ADDENDUM #08

INVITATION TO BID #01

ACES at CHASE

STATE PROJECT NO. 244-0044 MAG

A733-6

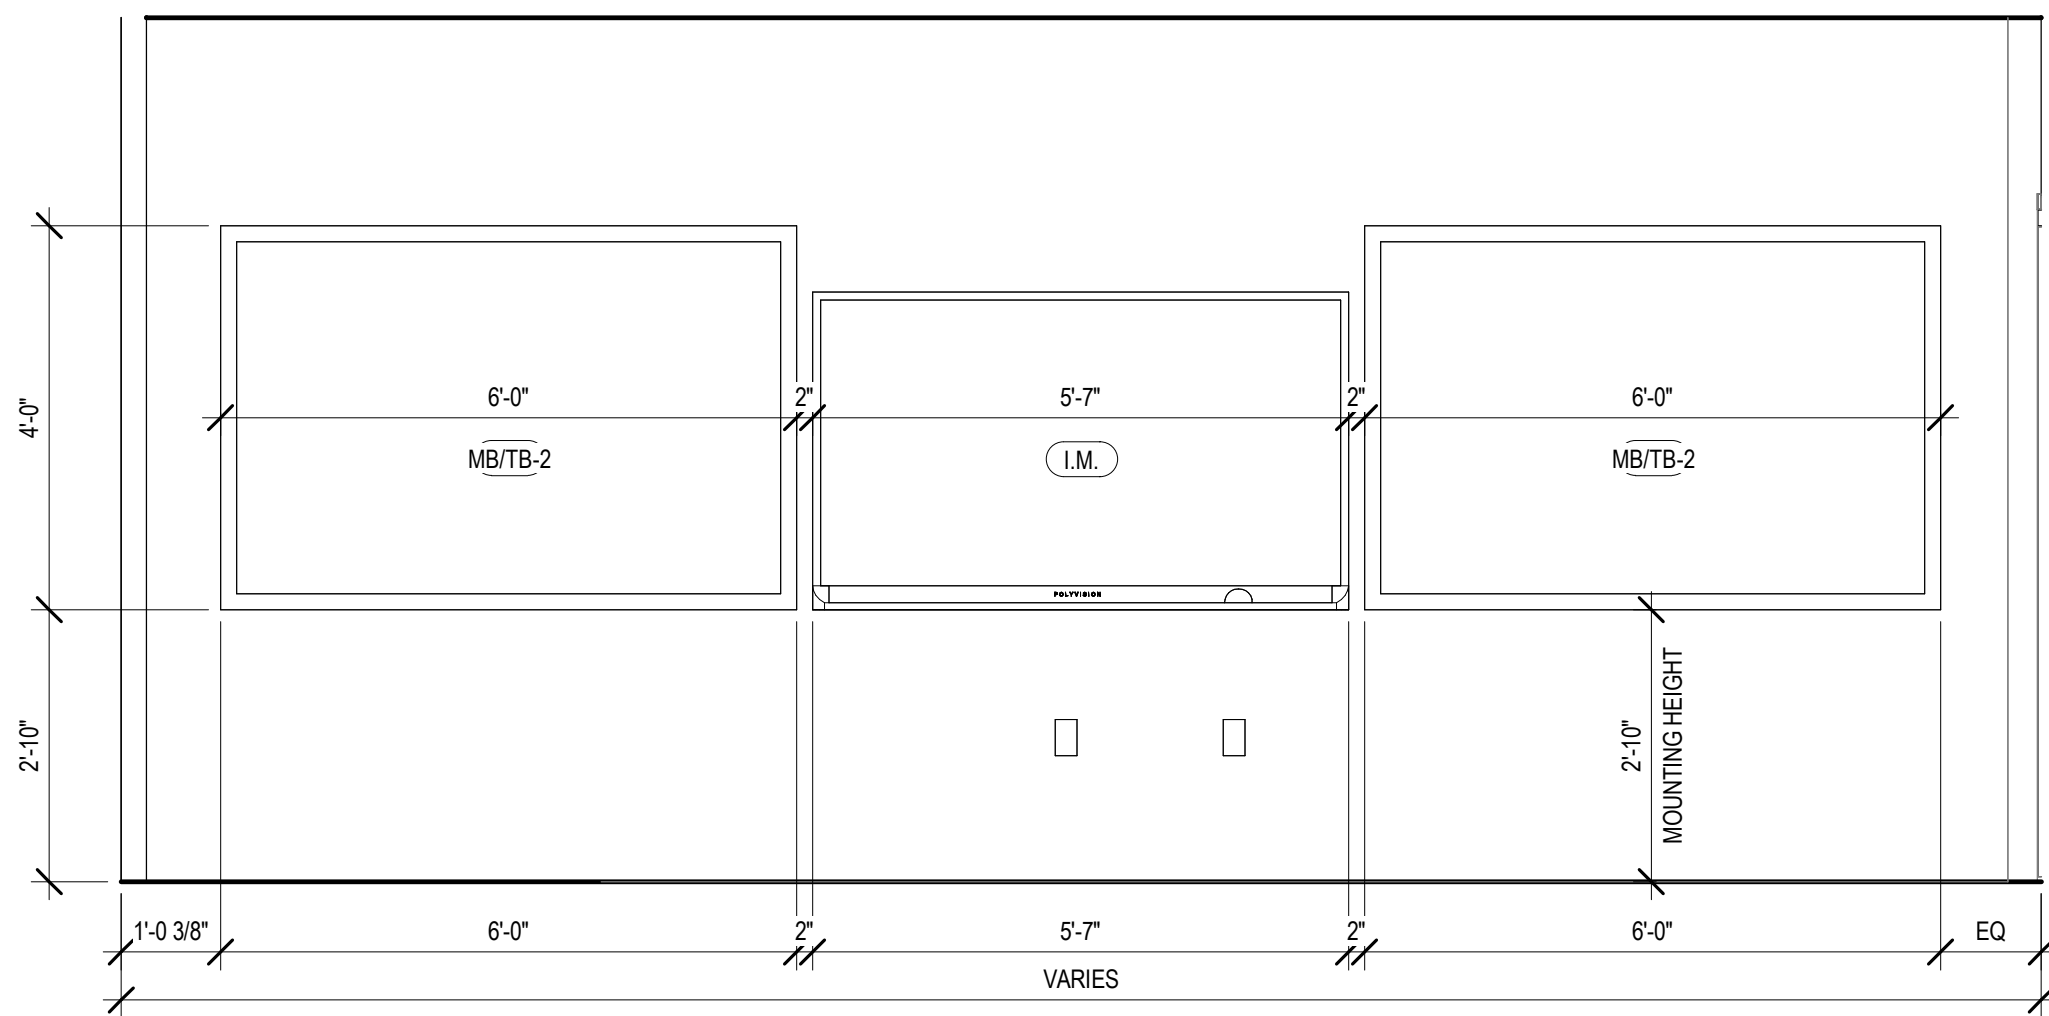
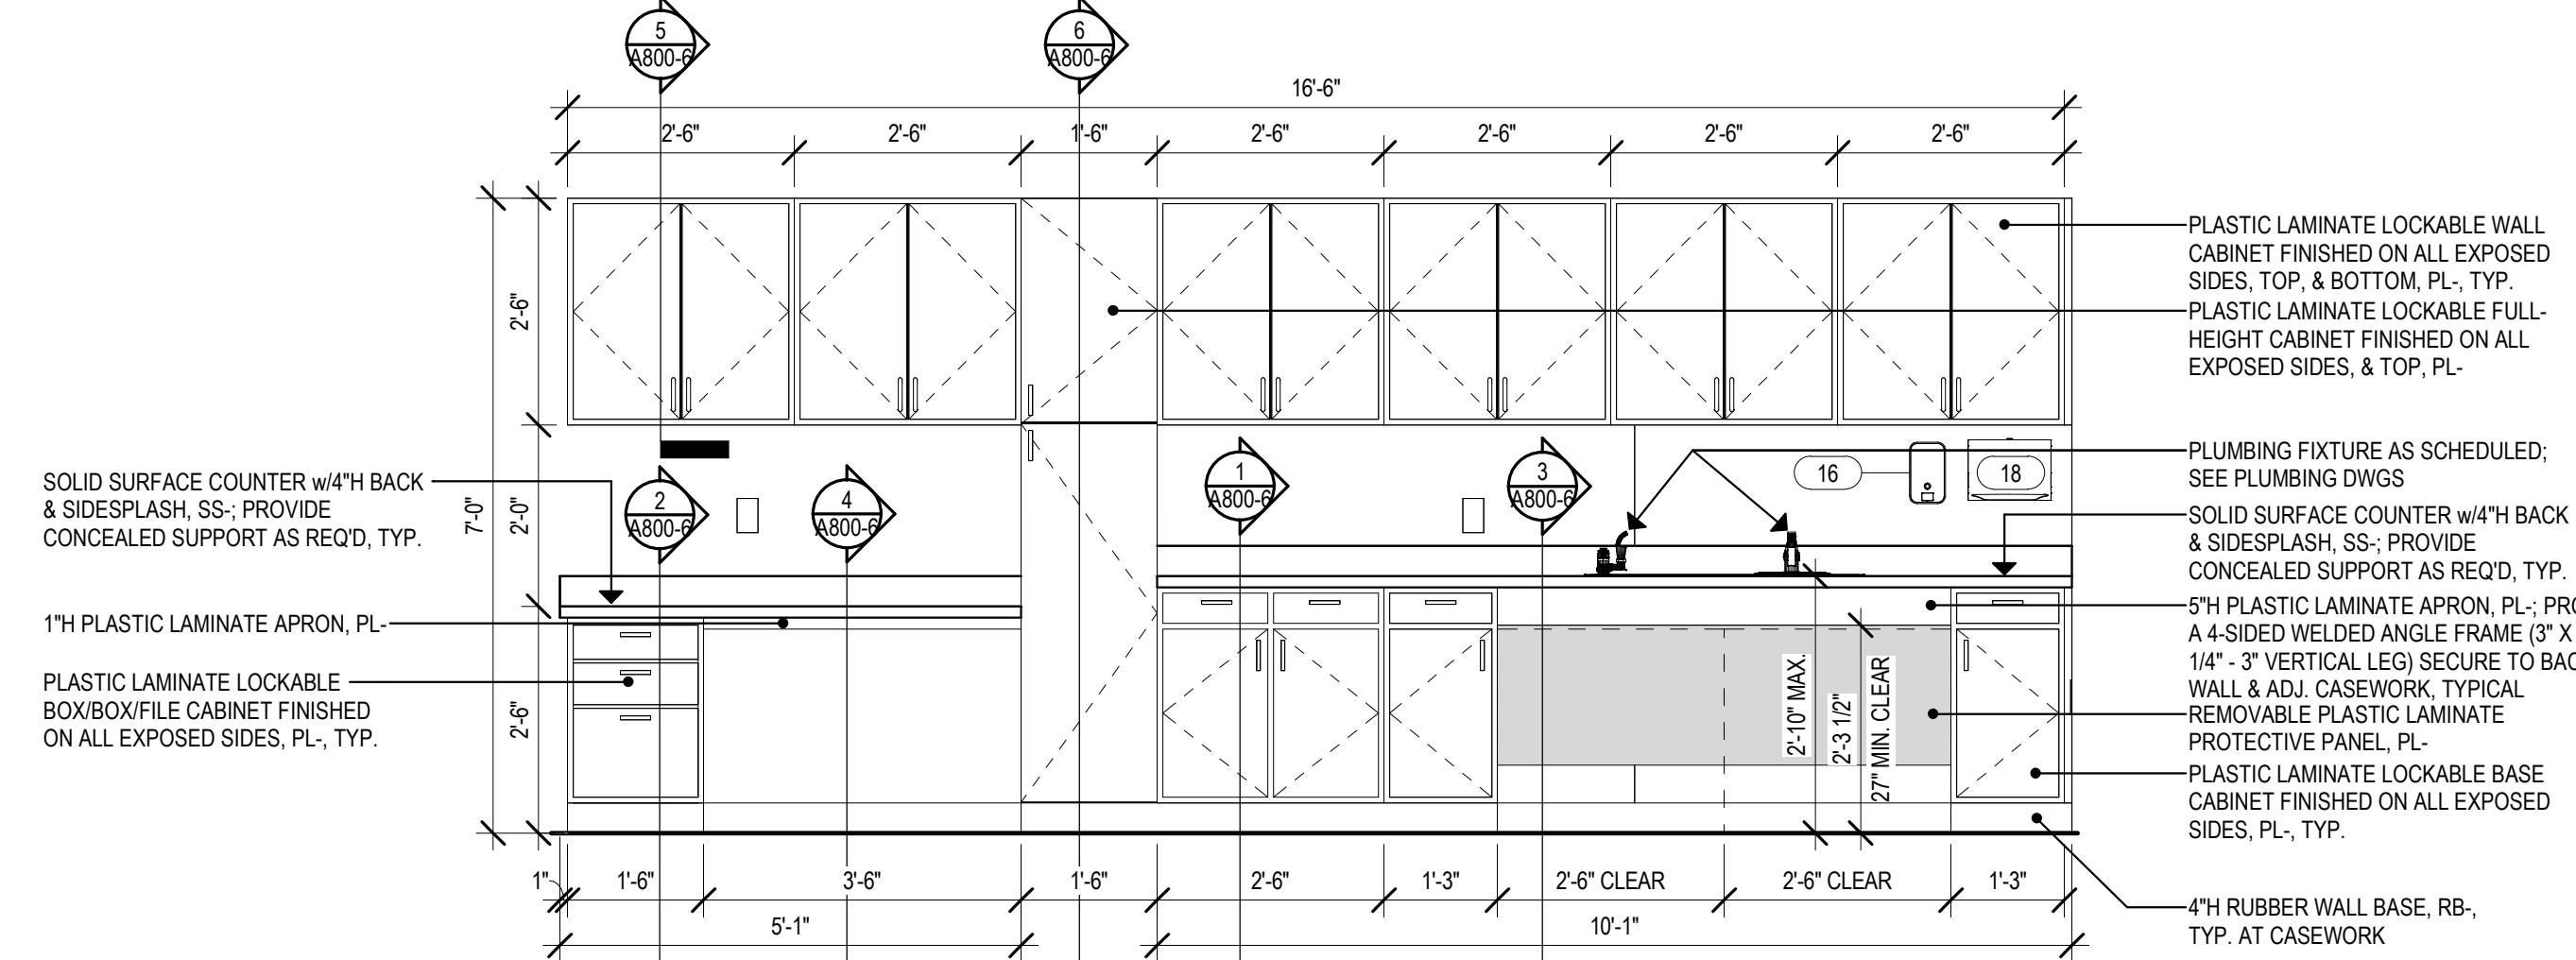
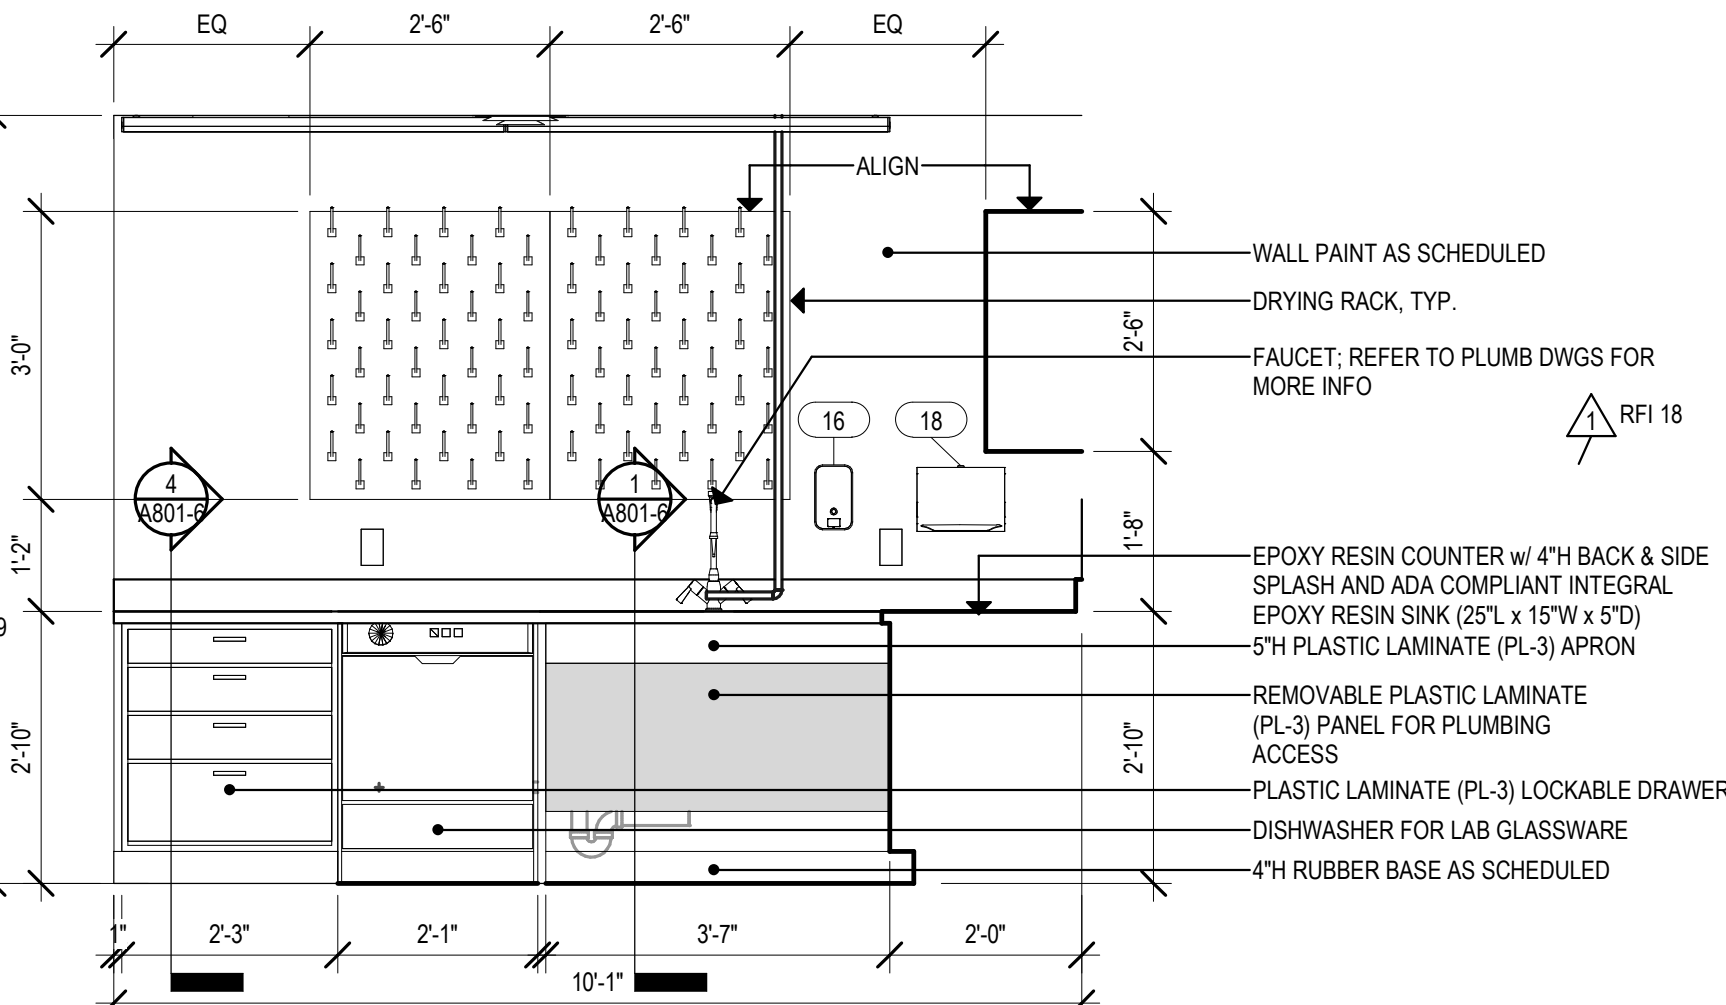
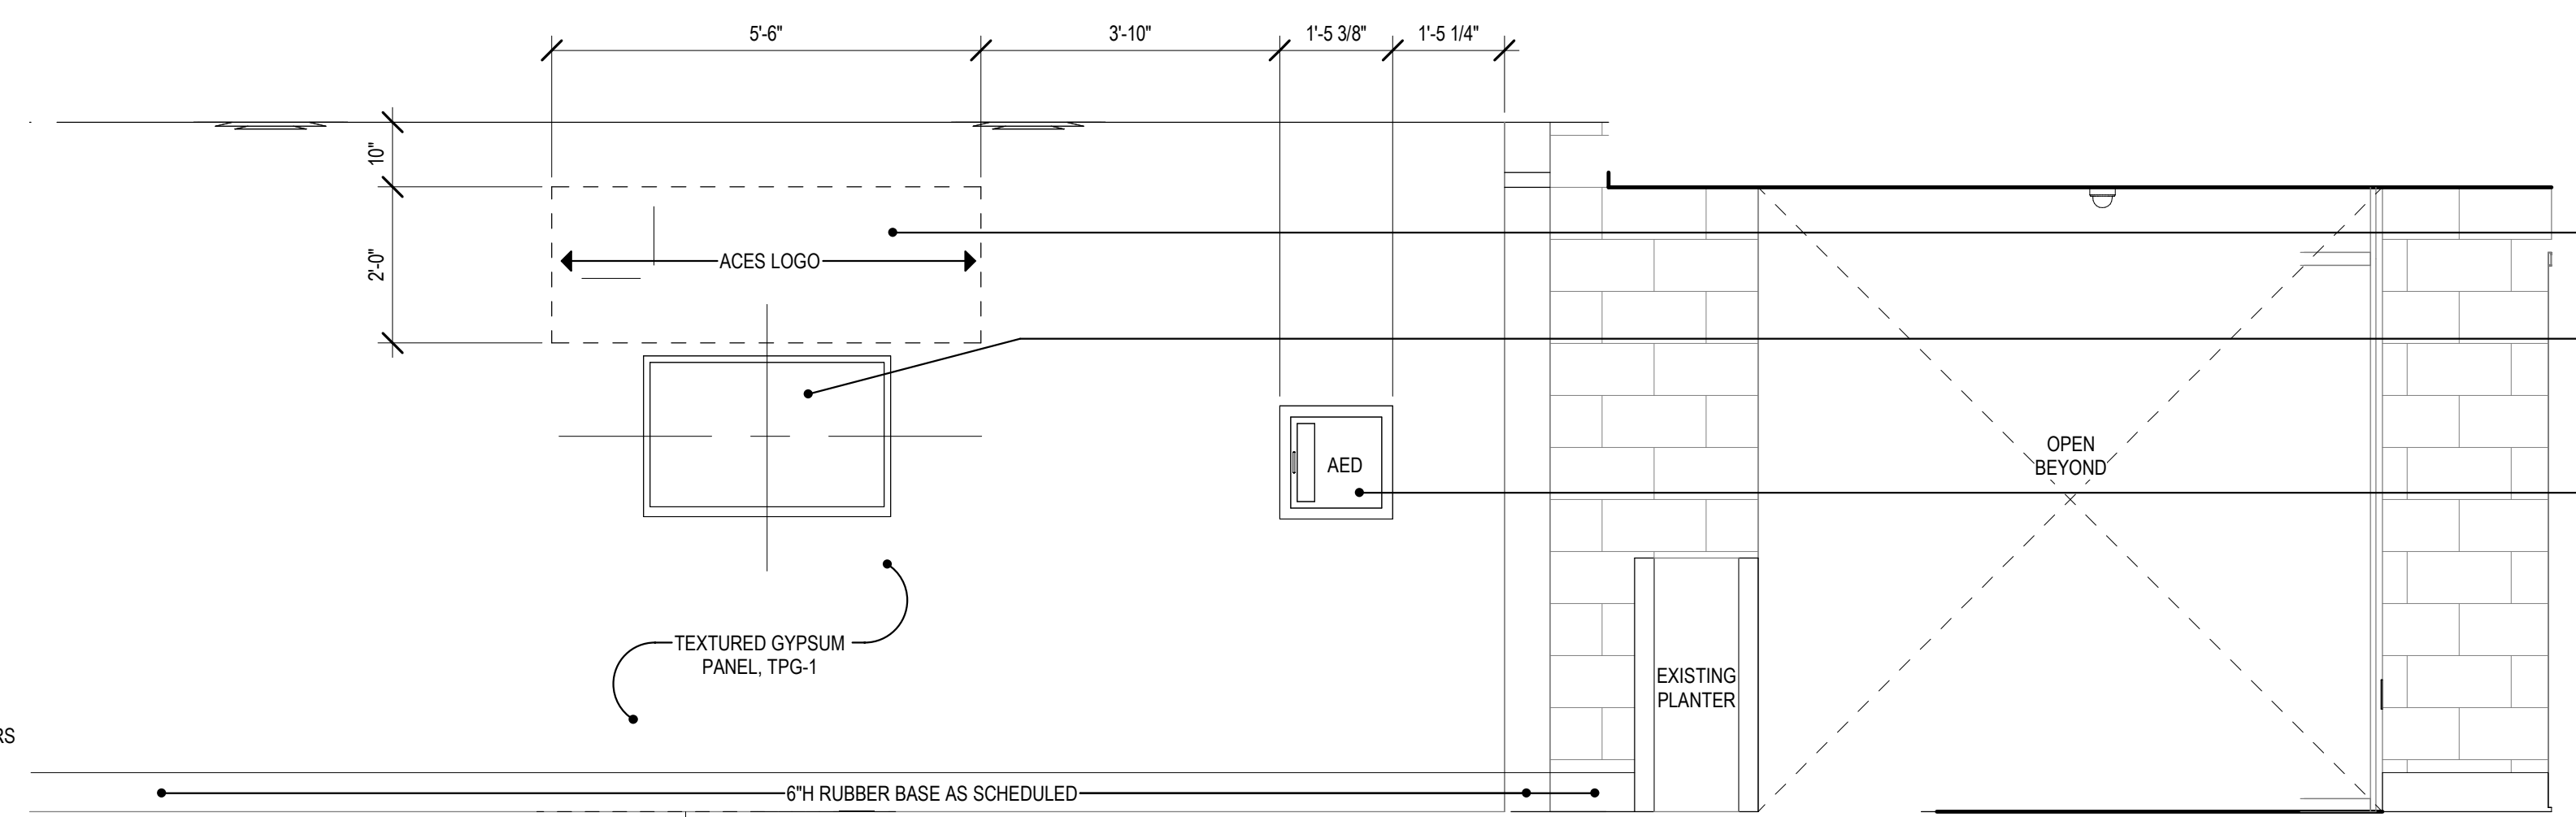
Add Item #145 RFI #12 (Building 6) **Question:** Is elev 4/A733 applicable to Classroom 139 and 142, reverse at 140, 143? And is key through taller base cabinets supposed to read 2/A801? **Answer:** Correct. No, Detail Tag to read 1/A800-6. Refer to Bulletin #3 for revised Drawing A733. -S/P+A-KD

- Elev 7/A733 has a floating detail key 9/A801 above the refrigerator. Is an upper cabinet to be provided? **Answer:** No. Refer to Bulletin #3 for revised Drawing A733. -S/P+A-KD

- Details 1, 2, and 3/A801 appear to be applicable to Lab Casework and Manufactured Solid Plastic Casework only; please clarify and revise details if necessary. **Answer:** Detail tags at Elevation 9/A733-6 are for countertop only. Refer to Bulletin #3 for revised Drawings A733-6 & A801-6. -S/P+A-RSB/KD
